Townsend Water Engineering  
20 the Crescent  
Newton  
Chester  
CH2 2BP

Your Reference: 19/2069/FUL Upper Bryn

Please find below our replies to Simons emails of the 18<sup>th</sup> Jan & 30<sup>th</sup> Jan. I have included both emails in appendix A for ease.

Appendix C: Updated drawings

Residential - Agricultural - Commercial	
Job	Proposed egg production unit at Upper Bryn
Title	Drainage Plan
Location	Upper Bryn Abermule Powys SY15 6LW
Client	W L Hamer
Scales	1:250 @ A1
Drawing No.	GEJ/SB/ 004 C
Drawn by	SAB
Date	09/06/2022

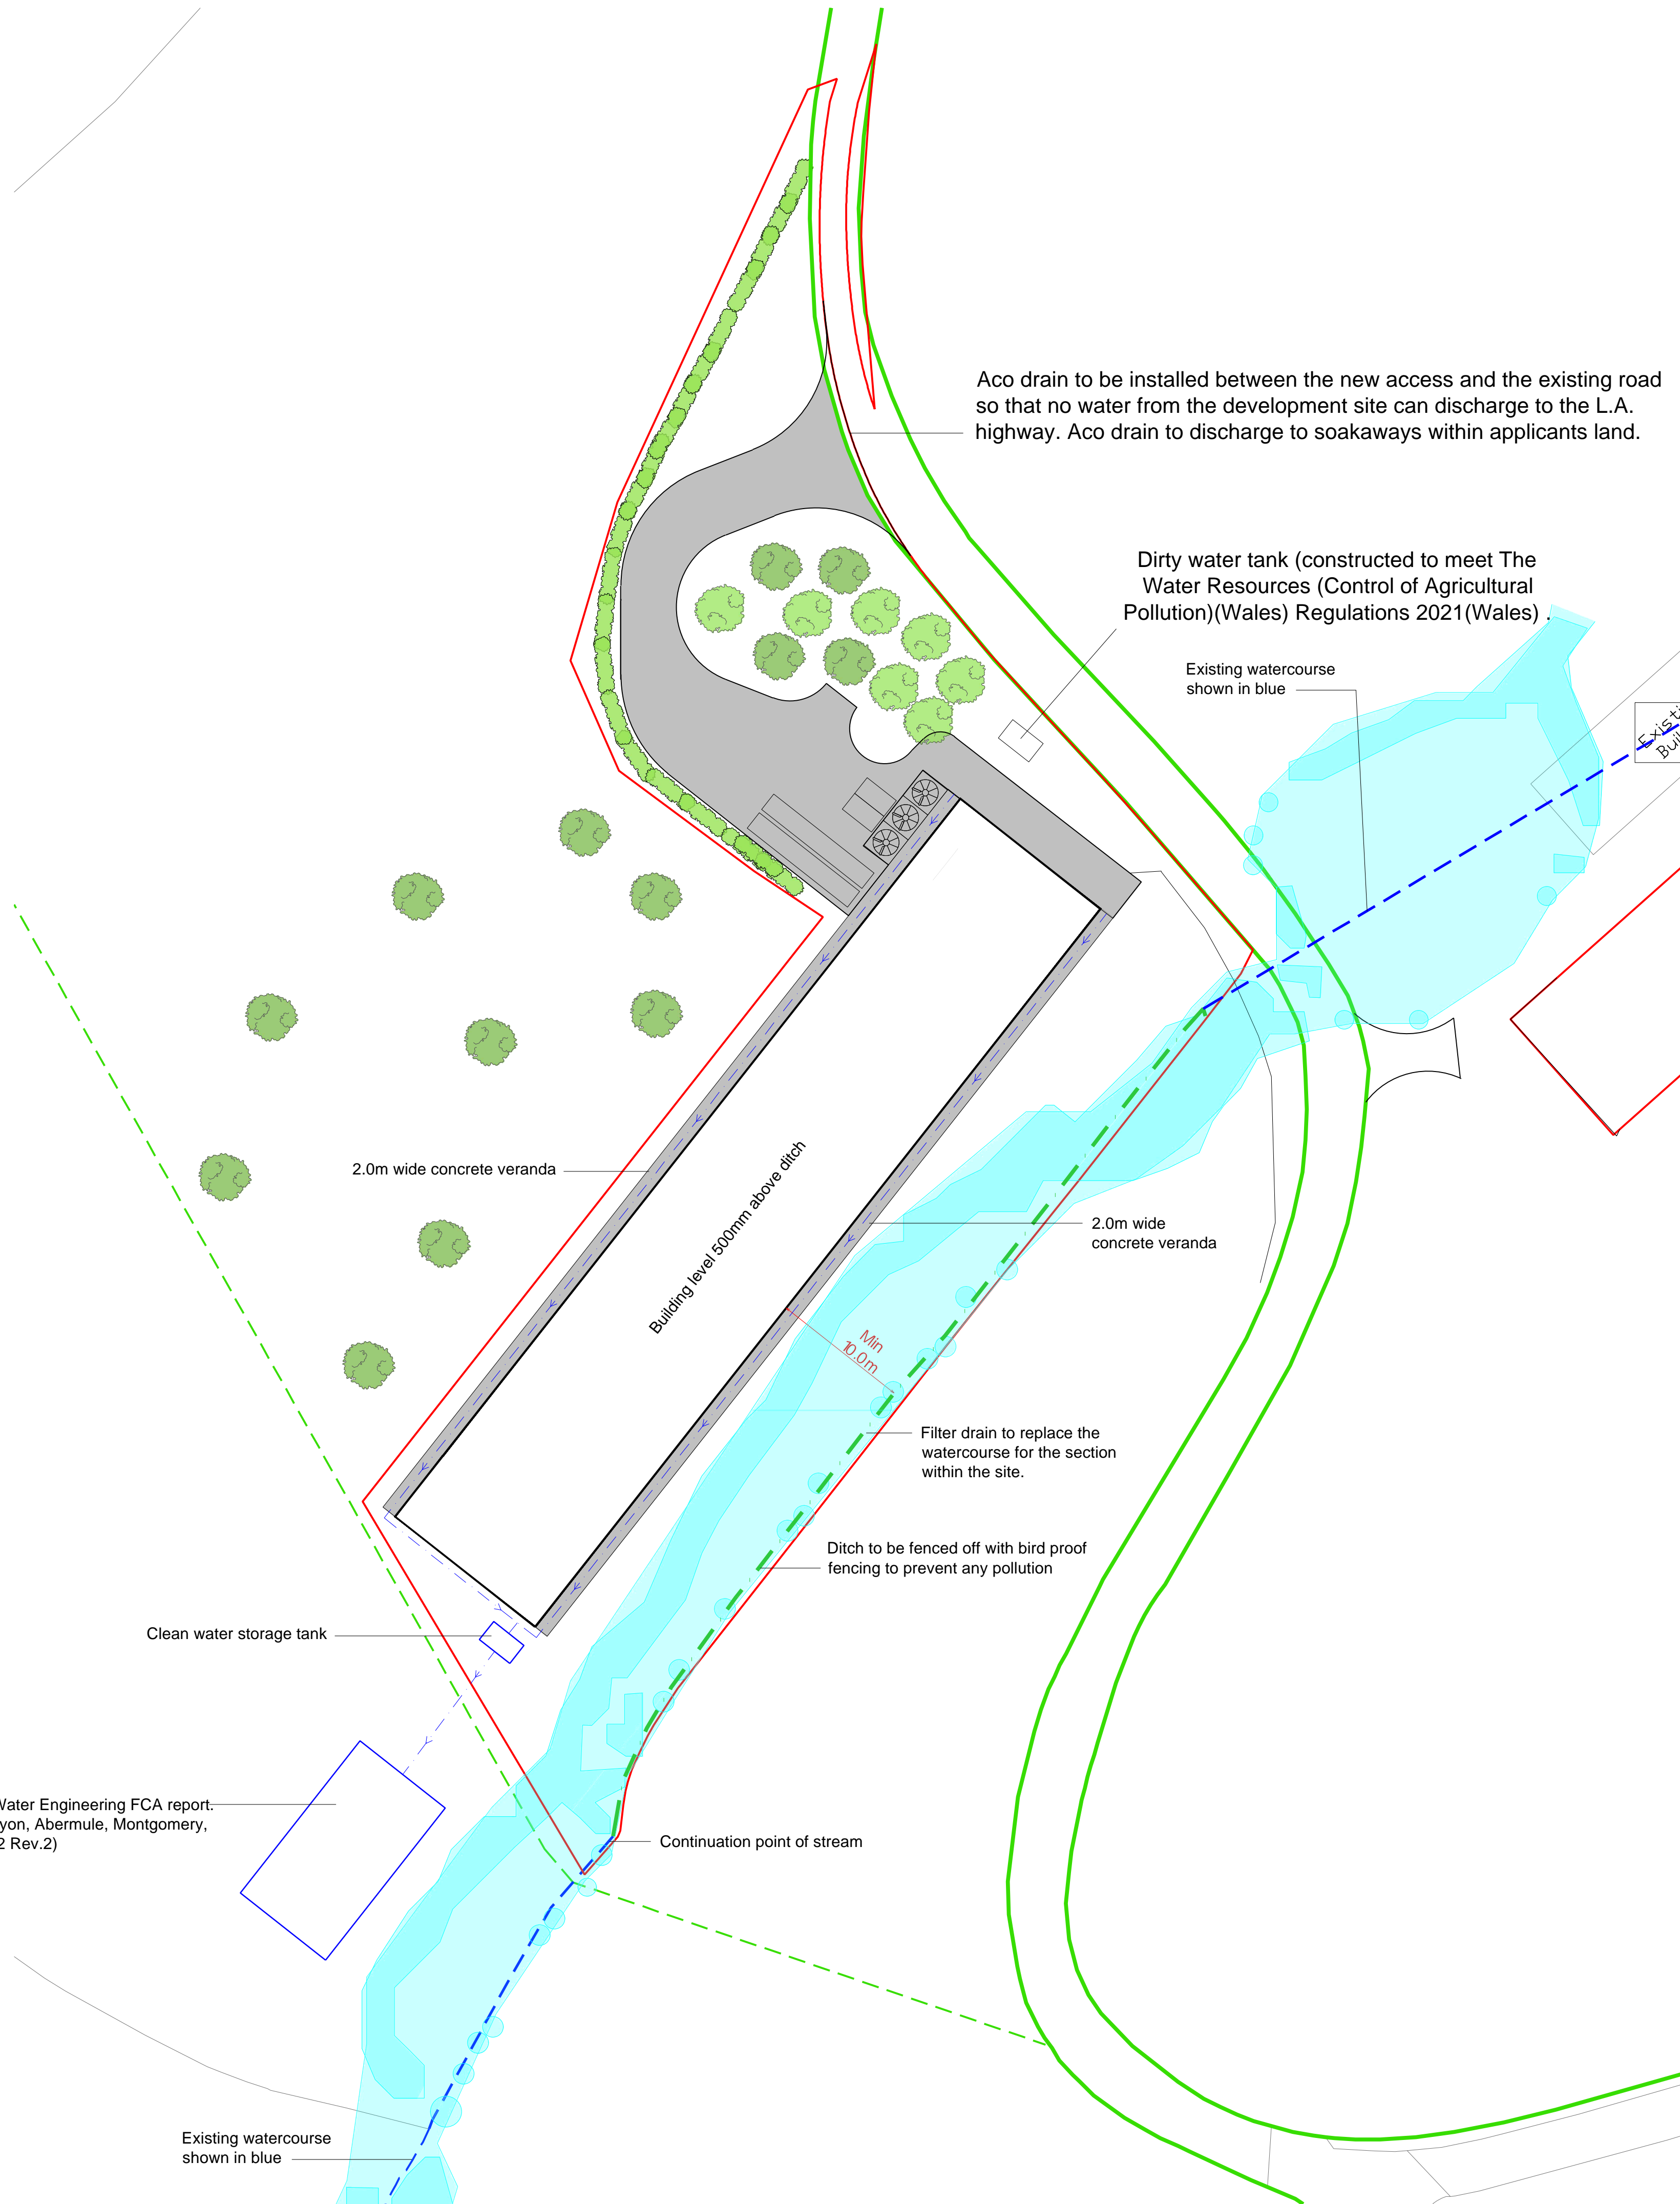
- There must be a demarcation area between the highway culvert and the new section of culvert. This can either be done by a manhole or by leaving a section open and creating a new headwall.

1. The response states that the building will be located 10m from the ditch, however the drainage plan shows that the building will be 9.3m from the site boundary, within which the watercourse is located. Please could this be clarified.

4. The proposed infiltration feature should not be located within the surface water flood extent. We also question why the drainage plan continues to show a connection to watercourse from the feature. Please could drainage details on the external hardstanding areas be illustrated on the drainage plan. We would not consider that a swale would provide sufficient treatment and so further stages within a treatment train or alternative drainage features would be required.

**There is a demarcation of the filter drain and the highway culvert. Please see Appendix C for the updated drawings**
  - The culvert trench should remain approx. 200mm below finished ground levels, creating a shallow swale, to ensure that should the culvert become blocked then it can overtop and run overground and back into the watercourse without flooding either the highway or new development.

**Please find all the drawings updated in appendix C. The building is over 10m away from the watercourse/ filter drain.**
  2. The response states that the original shed does not connection to the watercourse culvert. However, as the applicant has stated that there is only one culvert under the highway, Dwg. No GEJ/WL/005 suggests that the existing unit does connect to the culvert. We understand

**Agreed, please find the amended drawings indicating that the infiltration basin is outside of the floodplain and that there is no outfall from the infiltration basin. Please see appendix C.**
